**From:** Jeffrey Anecito <jeffrey.anecito@ableserve.com>  
**Sent:** Thursday, June 17, 2021 8:36 AM  
**To:** David Sellers  
**Cc:** Ryan Stroupe (R2S2@pge.com); Bob VanBlargan  
**Subject:** RE: Revised Bid request. (disregard the previous email)

**From:** David Sellers <dsellers@facilitydynamics.com>  
**Sent:** Wednesday, June 16, 2021 5:50 PM  
**To:** Jeffrey Anecito <jeffrey.anecito@ableserve.com>  
**Cc:** Ryan Stroupe (R2S2@pge.com) <R2S2@pge.com>; Bob VanBlargan <BVANBLARGAN@hotmail.com>  
**Subject:** RE: Revised Bid request. (disregard the previous email)

David, I had two concerns about the bids received.

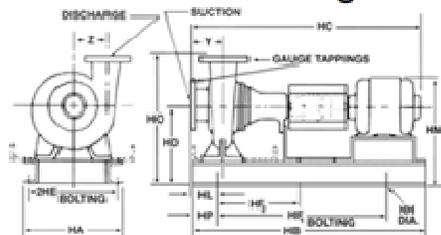
1. The bid to trim or provide new impellers doesn't have list new bearings, unless it's included in the seal set. If it's not can you make a change to this bid so we can replace the bearings too. I'd hate to ask ownership for more money to replace the bearings and install new seals if the bearing fails a short time later.

*My line item for the Seal Set should more appropriately have read Seal Set and Bearings. My quote from the local rep included both.*
